## PLAN REVIEW SHEET

**Petition:** 2012-006

**Attachments:** **Waiting Pad Spec. 60.01A**

**WAITING PAD ONLY  
WITH PLANTING STRIP**

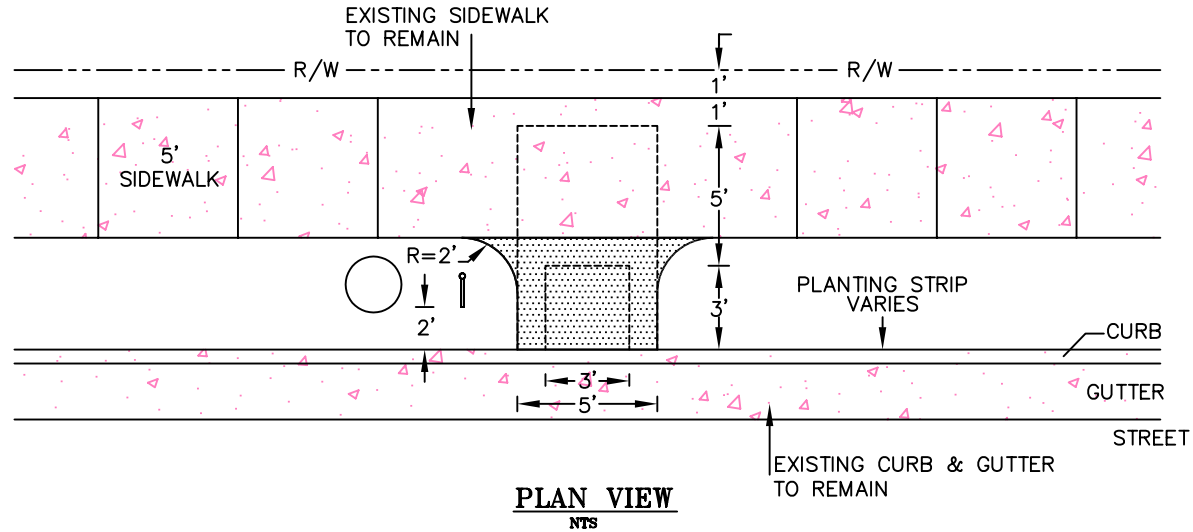
CATS requests that the Petitioner provide a concrete waiting pad as shown on the attached specification. Please contact Budd Early at CATS (704.432.2557) if there are any questions regarding this request. Thank you.
